From: [REDACTED]
Sent: Monday, 8 November 2021 2:48 PM
To: [REDACTED]
Cc: [REDACTED]
Subject: RE: OFFICIAL: PA2000978-West Mokoan Solar Farm - RFI Response

I've got a couple of quick follow up questions on the noise modelling.

Figure 2 Generation Profile – Summer Day

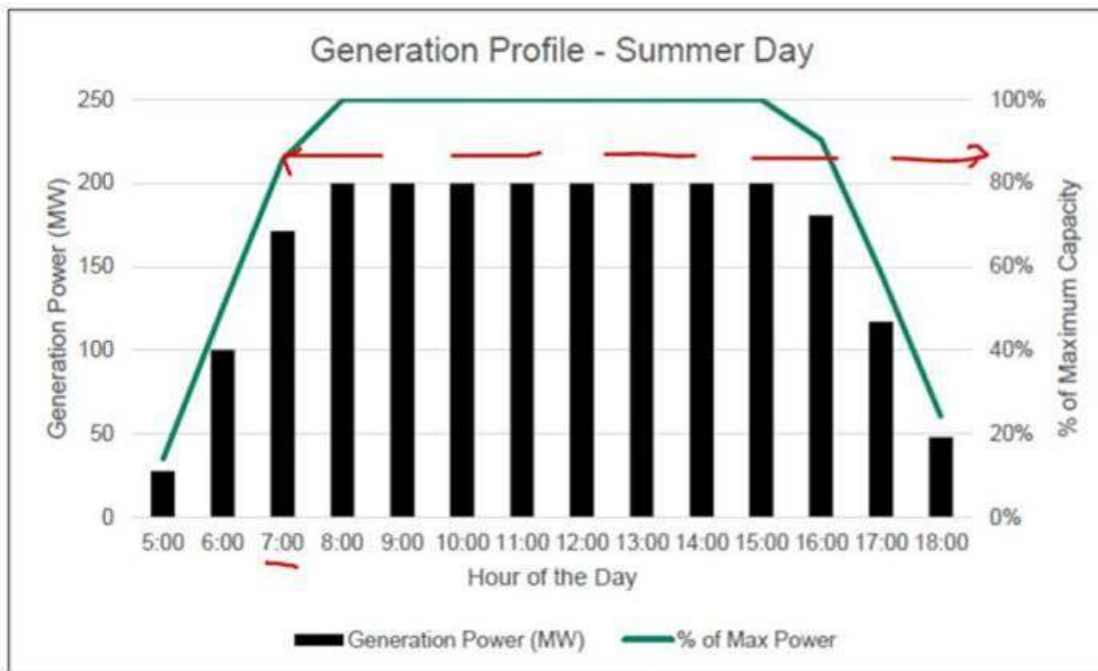
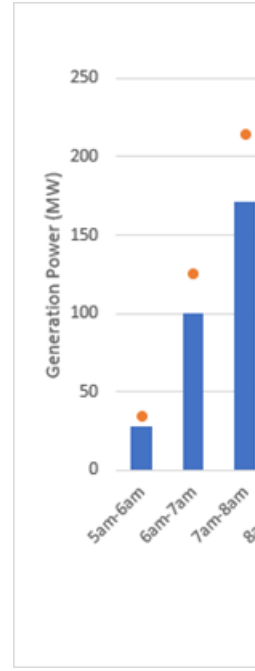
- 2. Figure 2 is stated to not show generation exceeding 50% before 7am but it appears to show up to 85% generation capacity at 6:59am: Have I understood the graph correctly?

- o The graph shows that 50% is reached during 6am - 6:59am ('Night Period') and 85% is reached during 7am - 7:59am ('Day Period') but this format appears to be misrepresenting the data .

- o We have provided a re-formatted graph below that shows generation capacity at no greater than 50% during the 6am-7am period (within the 'Night Period').

- o We also note that the profile does not account for daylight savings as PVsyst, the software used to create the profile doesn't take DST into account, and the winter time (non DST) is the reference. So we would expect the generation to occur an hour forward in the Oct-Feb period. PVsyst has an online forum which states that here:
<https://forum.pvsyst.com/viewtopic.php?t=372#:~:text=NB%3A%20As%20with%20most%20of,the%20Winter%20time%20as%20reference.&text=Now%20PVsyst%20fixes%20limits%20to,%2D1%20o%20%2B2%20hours.>
